JAMES A. FITZPATRICK NUCLEAR POWER PLANT

Amendment No. 9
License No. DPR-59

SAFETY EVALUATION BY THE OFFICE OF NUCLEAR REACTOR REGULATION

SUPPORTING AMENDMENT NO. 9 TO FACILITY LICENSE NO. DPR-59

Figure 1 Plug Installed in Core Plate

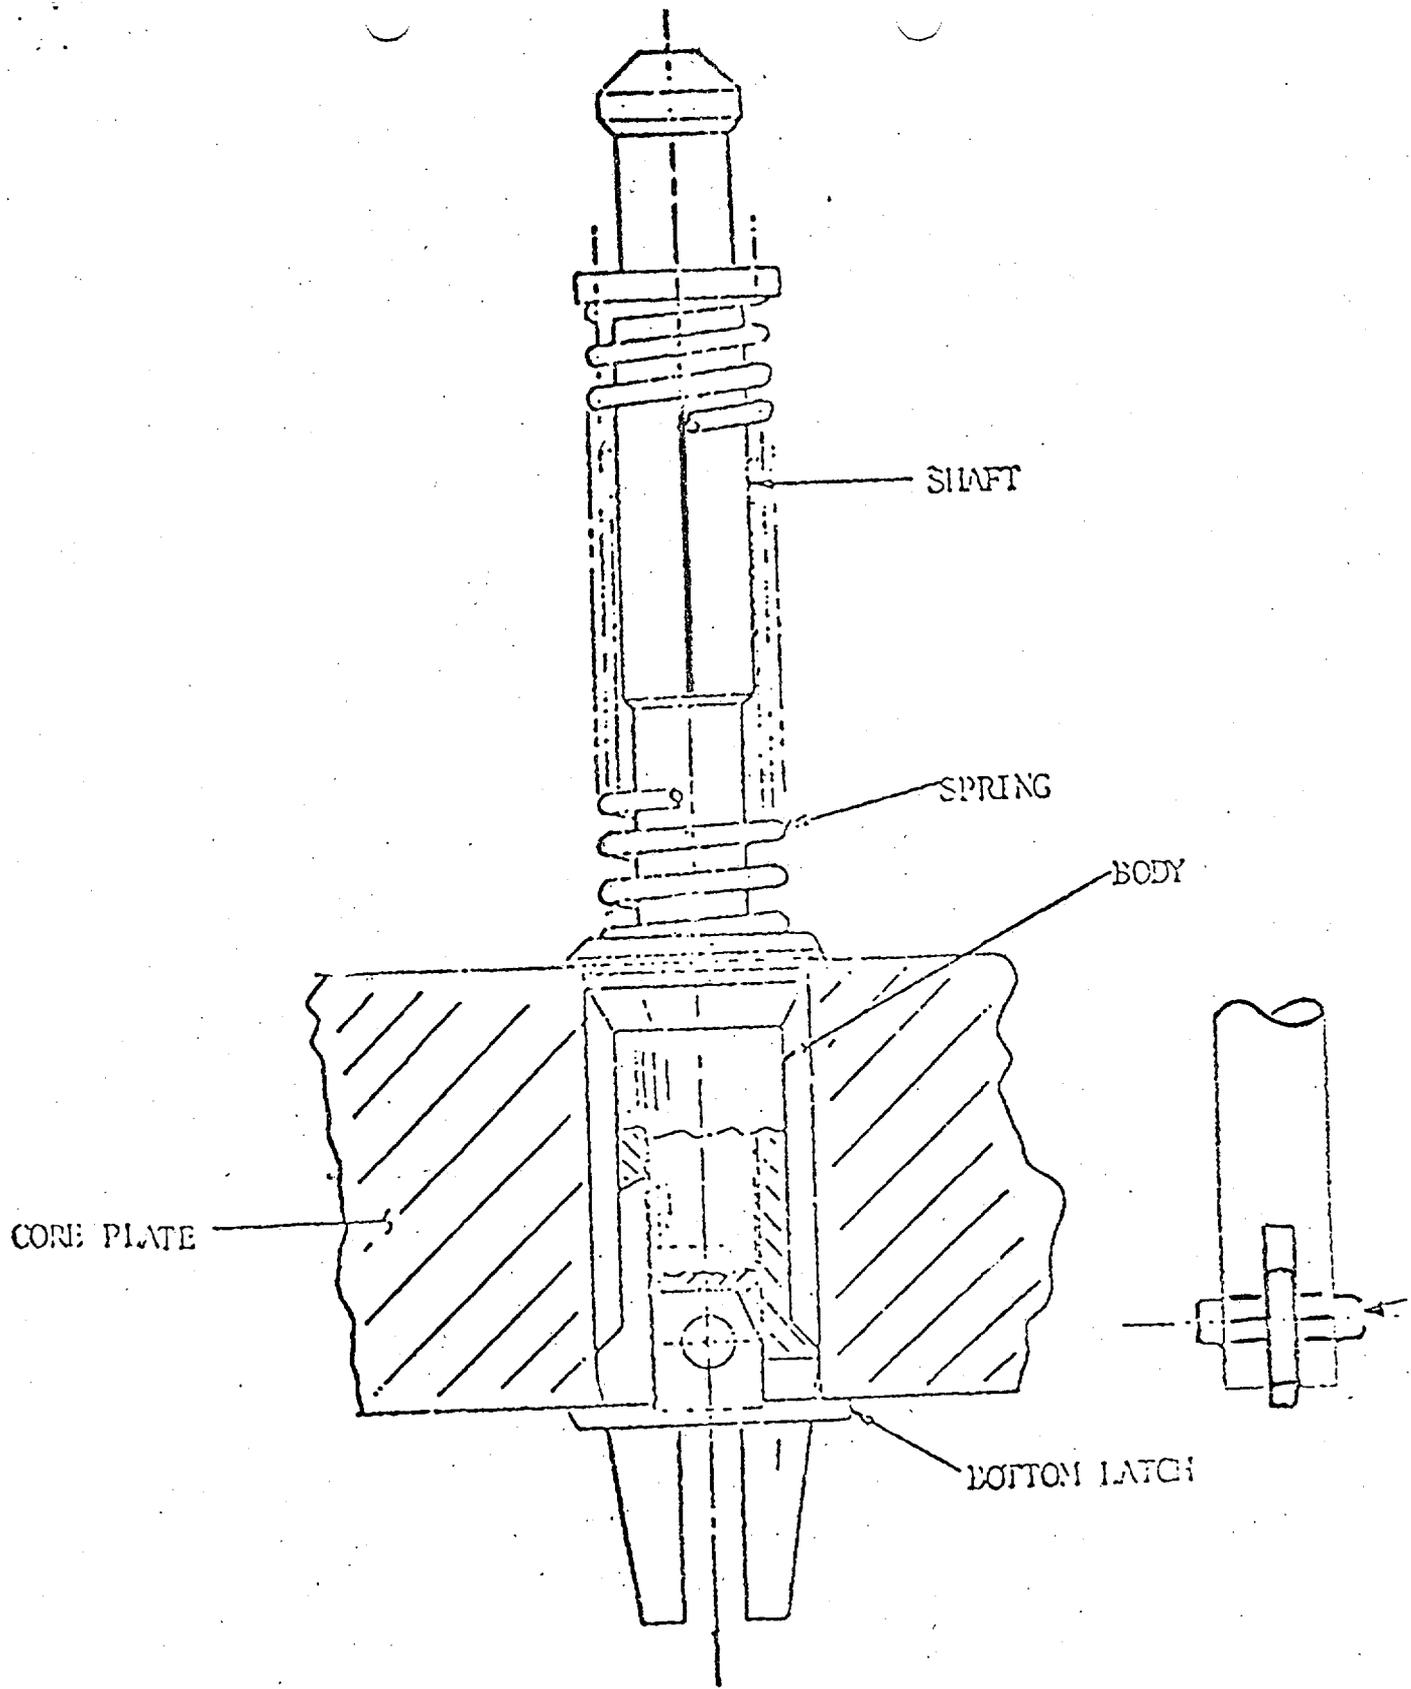
The plug consists of five basic parts, as shown in Figure 1. Identical plugs have previously been installed at Vermont Yankee, Pilgrim, Cooper and Duane Arnold. The body of the plug provides a means of guiding the device into the bypass flow holes as well as a shoulder to support the plug and form a seal against water flow. The shaft extends through the body. A knob is provided at the top of the shaft to provide a means of grabbing the plug during installation and extraction. At the bottom, the latch is attached to the shaft by a pin. The latch is free to rotate during installation. The spring acts against the body and shaft during normal operation to provide the force necessary to offset the pressure differential acting on the body.

During installation, the plug has its latch rotated 90 degrees from its installed position and withdrawn and locked in the body. The shaft is gripped by the installation tool, and the plug is inserted into the bypass flow holes. The body engages the rim of the hole. The shaft is pushed to its full extension, thus lowering and unlocking the latch below the underside of the core plate. The latch then rotates 90 degrees and bears on the bottom of the core plate. After insertion, the plug is pulled with about a 30-pound force to test the placement.

The plug can be removed by gripping the top of the shaft with an extracting tool and applying a force of about 500 pounds. The latch's legs will be plastically deformed and the entire plug withdrawn. The plugs previously installed at Vermont Yankee were removed with no abnormalities or loose pieces reported. The force required for removal varied from 500 to 1300 pounds.

Based on a review of the design, the installation methods, and the previously successful operating experience at Vermont Yankee, Pilgrim, and Duane Arnold, we conclude that the plugs can be installed without damage to core components, that they will not fail so as to result in loose parts in the core or result in unplugging of the bypass flow holes, and that they can be removed, if necessary, without damage to core components. Thus, the modification is reversible.

Accordingly, we conclude that the installation of the plugs is acceptable. Operation with plugged bypass holes is still under review and will be the subject to a separate licensing action.
